# FILIA VISUAL

## **VISUAL STATEMENT FOR THE CLANWILLIAM DAM RAISING PROJECT**

This specialist statement has been prepared to inform an application for the amendment of the existing Record of Decision (RoD) issued for the Clanwilliam Dam raising project. The Environmental Authorisation (EA), issued in 2009 under the Environmental Conservation Act, included four conditions that the Department of Water and Sanitation has requested be reconsidered for possible amendment or removal. The current amendment application is being undertaken by Zitholele Consulting in terms of the National Environmental Management Act 107 of 1998 (NEMA).

*Figure 6: Site visit diagram showing georeferenced photograph locations (Smit, 2025)*

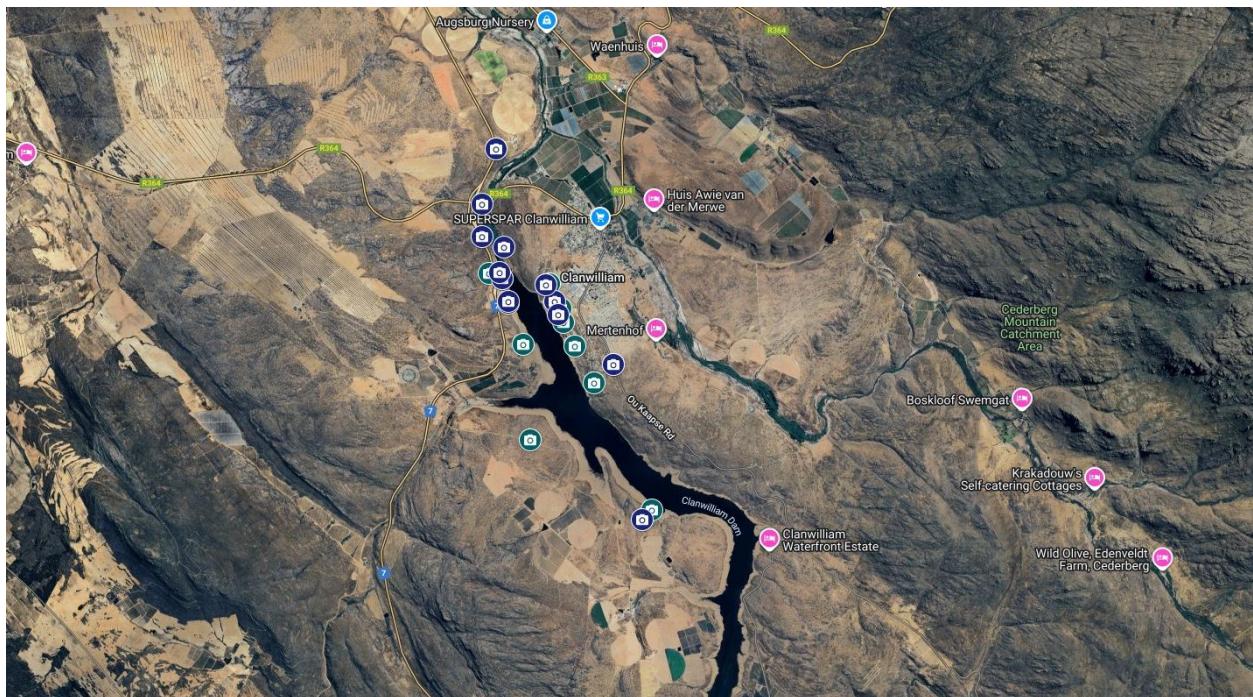
The locations of photographs were guided by those taken in the original VIA, with supplementary photographs captured to document newly visible aspects and disturbed areas that have emerged during the construction phase. Figures 7–19 provide side-by-side comparisons of key views identified in the original VIA prepared by Ninham Shand (2006) with updated images taken by the author in 2025.

Figure 22: Section 02-02, showing total height of the dam as well as the (significantly taller) intake tower (Department of Water and Sanitation, 2017)

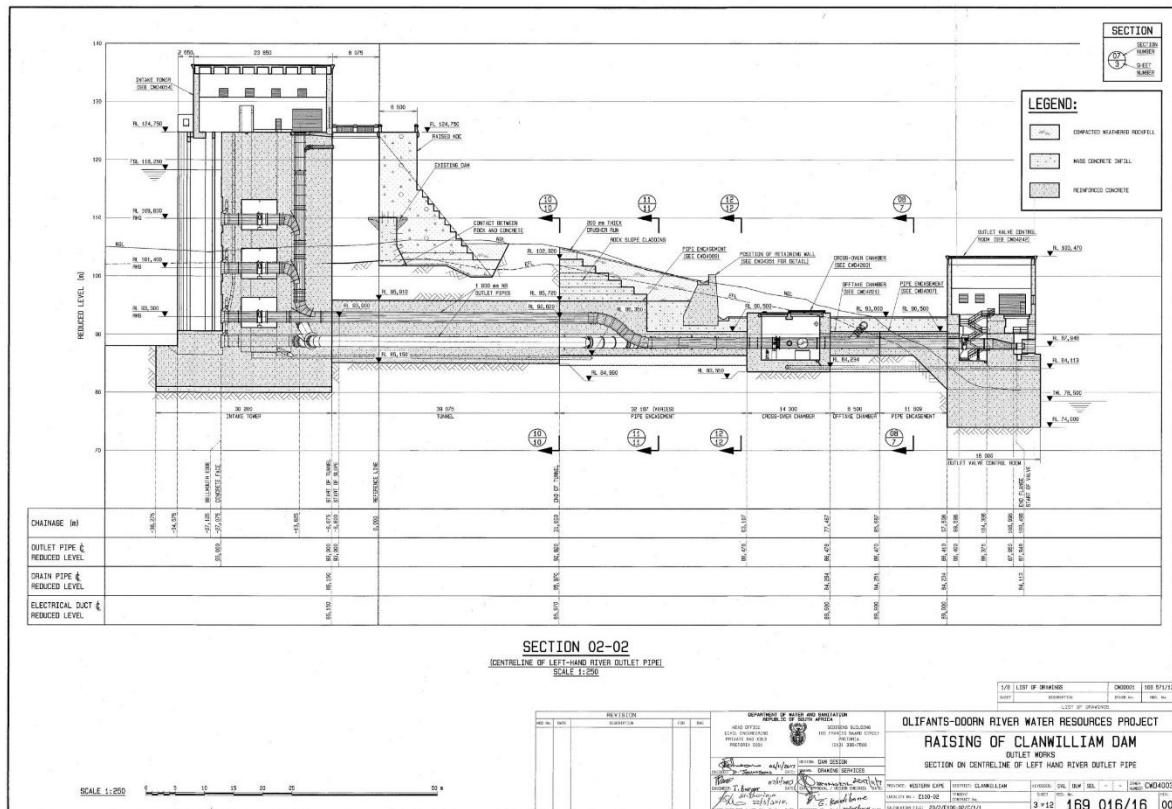
It should be noted that the VIA does not make mention of the intake tower illustrated in Figure 23 above. This structure, although it does not raise the overall level of the dam wall, was either not part of the design at the time of the writing of the VIA, or it was overlooked as a visible element requiring mitigation. See Condition 1 & 2 for further detail.

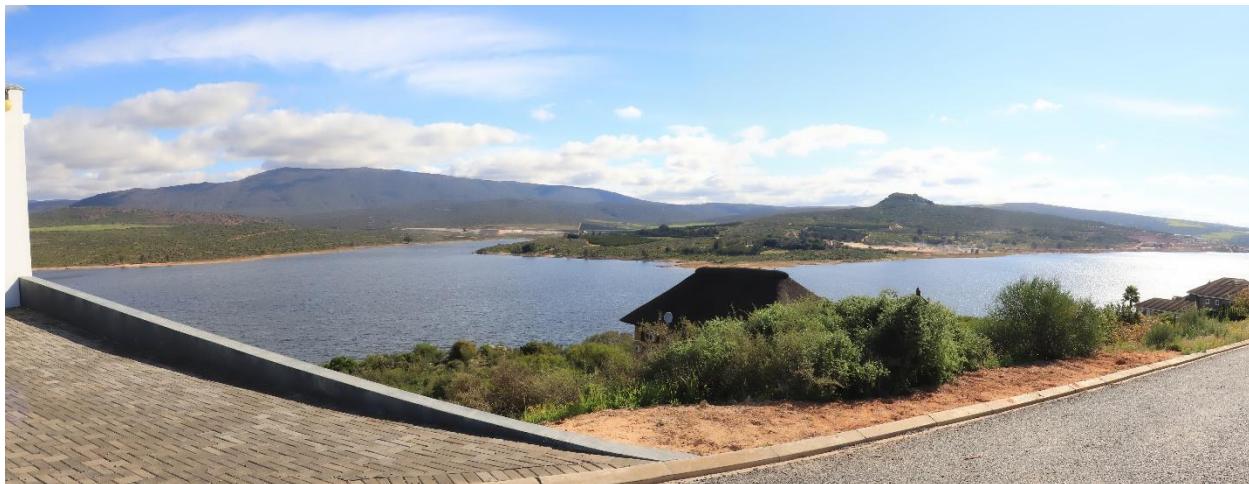
As shown in Figures 29, 30 and 31, planting trees along the eastern shore of the dam will not effectively screen views for most sensitive receptors, many of which are located at higher elevations than the tops of the tallest trees. Localised planting in key positions is a more effective method than restricting planting to the eastern shore alone. It would therefore be preferable to identify specific locations in need of screening with direct lines of sight and implement screening measures at those points.

Findings from the fieldwork underscore the necessity of this approach. Figures 28–31 show that tall trees planted along the shoreline do not adequately screen elevated receptors, making localised planting at receptor sites more effective than restricting interventions to the eastern shore alone. The anticipated inundation of mature trees within the municipal resort will also alter sense of place and reduce the valued shade and screening historically provided by these trees. The long construction period further demonstrates the need for planting to mitigate construction-related disturbance rather than the dam wall alone, as these impacts are both more visually intrusive and more disruptive to daily life.

#	Condition	Proposed condition wording: 22 October 2025 revision
1	<i>G.15.1.: Trees must be planted for visually sensitive receptors along the eastern shore of the dam to screen the raised wall.</i>	<b><i>Recommendation: Supported in principle. Remove condition. The content of this condition has been included in Condition G.15.2.</i></b>
2	<i>G.15.2: DWAF must provide saplings to those who would like to plant and screen the raised wall.</i>  <b><i>Recommendation: Supported in principle, with amendments</i></b>	The applicant must make suitable saplings and planting guidance available to the local municipality, affected landowners and community members who wish to establish supplementary planting on their properties or within public areas to mitigate any and all visual impacts associated with the project. Tree planting specifications and guidance on the selection of species, planting locations and irrigation (developed by a registered landscape architect) must be provided along with the sapling.  The applicant must pro-actively advertise this opportunity to affected visual receptors through appropriate local channels (such as municipal notices, community meetings, or targeted communication with directly affected households, businesses and organizations). Advertising must commence immediately, and re-advertised monthly until the end of the construction period.
